Department of Energy
Washington, D.C. 20545
Docket No. 50-537
HQ:S:82:105

SUMMARY OF HCDA ENERGETICS MEETING HELD ON SEPTEMBER 21, 1982

CFBRP HCDA ENERGETICS MEETING

QUESTIONS CS760.178B5, -C6, -C7

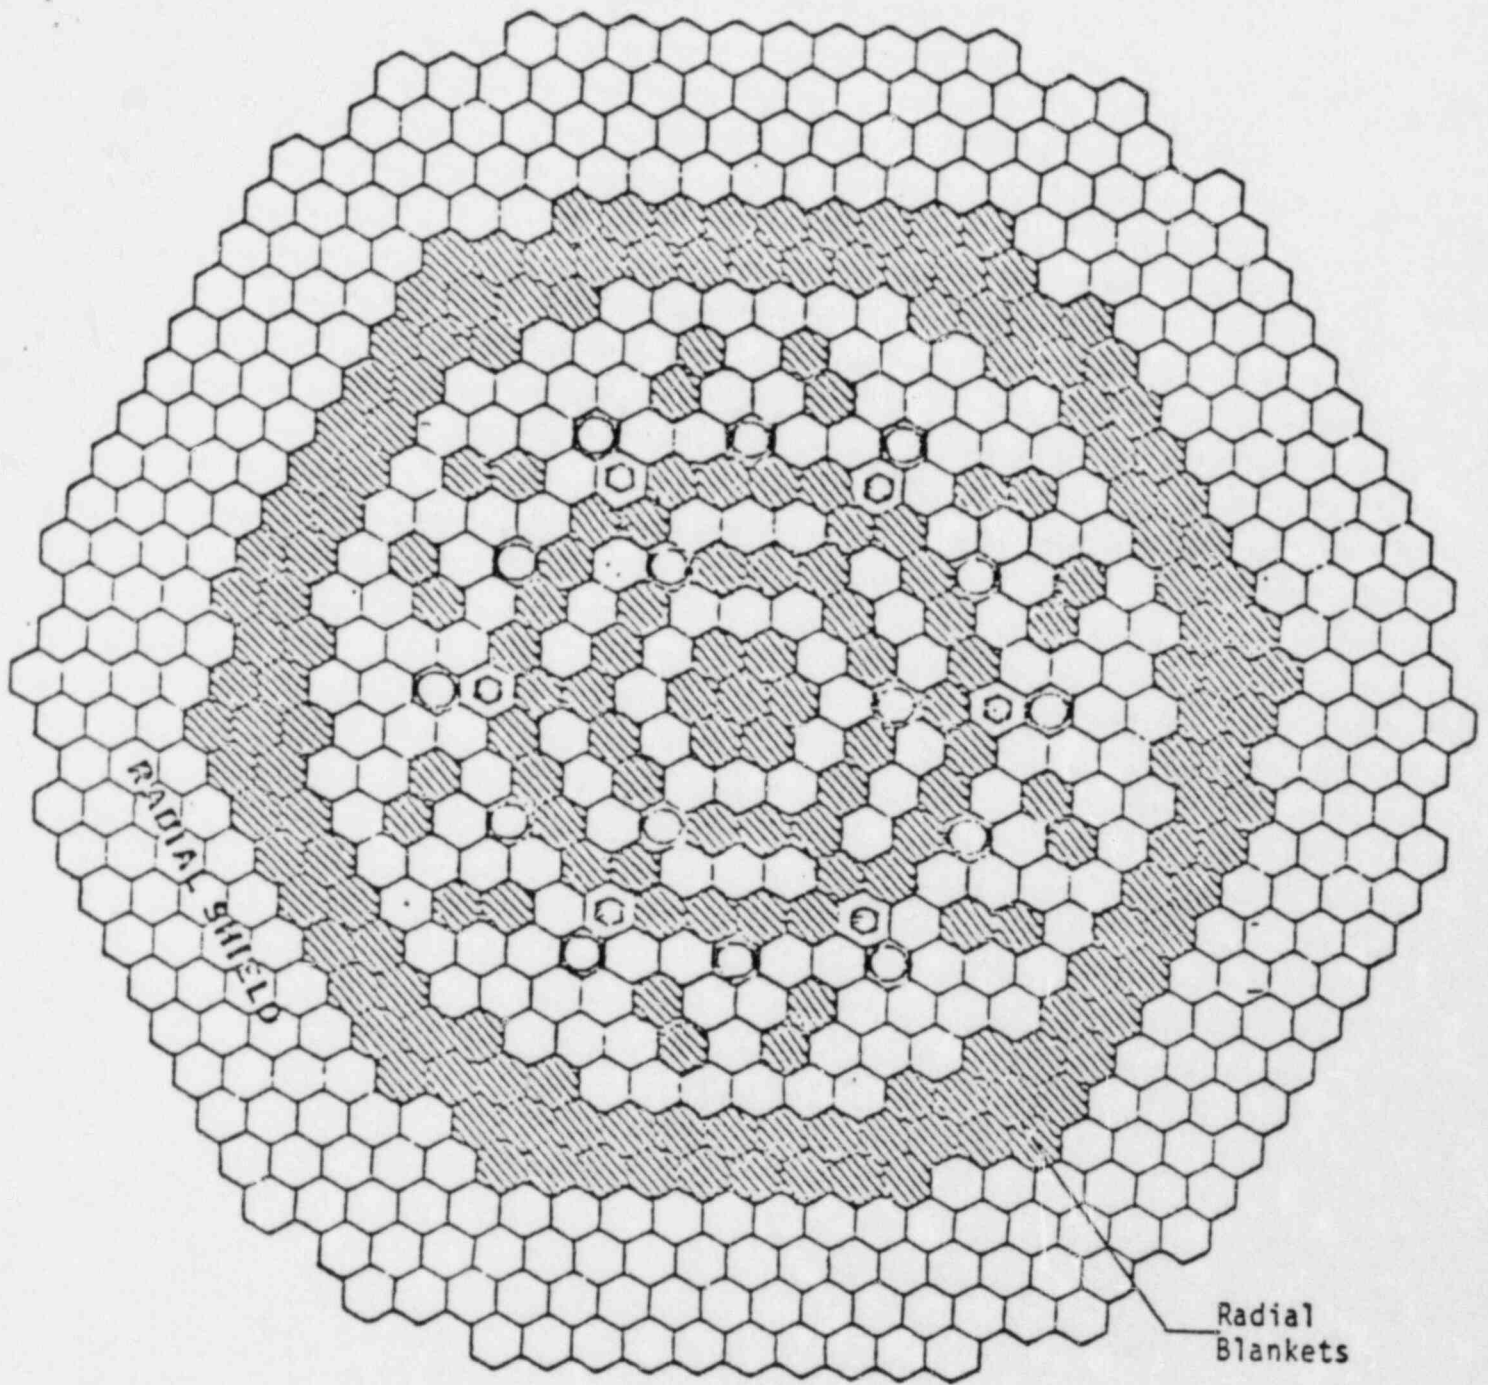
- B5. What is the basis for maintaining continuous subcriticality in the high heat loss environment of early melt-out phase? What are the fuel losses (quantified), taking into account uncertainties in removal path geometries, driving pressures and freezing mechanisms?
- C6. What degree of subcriticality is required to prevent pool recriticality from thermal and fluid dynamics upset conditions? What is your position on the potential for small recriticalities to amplify? What is the justification for your position?
- C7. In assessing benign termination from the boiled-up pool, justify the fuel removal mechanisms and rates. In particular, assess the potential for upper pool sodium entry via rapid condensation of steel vapor pressure.

SUMMARY RESPONSE TO QUESTIONS

1. Once molten fuel becomes available on an assembly basis, mild recriticality events may be possible but they are limited in amplitude and do not amplify.

2. Multiple paths for fuel removal are available on a short time scale, relative to the melt-out of internal blanket assemblies. Correspondingly, fuel removal is not overly sensitive to fuel penetration model assumptions and fuel escape impedances.

3. There is always time for sufficient fuel removal, i.e. about 40% of the driver fuel, to achieve permanent subcriticality prior to loss of the annular inner blanket barrier.

4. The accident sequence will terminate benignly without the development of a homogeneous large scale confined pool phase as defined in (Ref. QCS760.178B5-1).

5. Sodium re-entry via steel vapor condensation can be ruled out on the basis of excessive sodium vaporization when liquid sodium comes into contact with steel vapor.
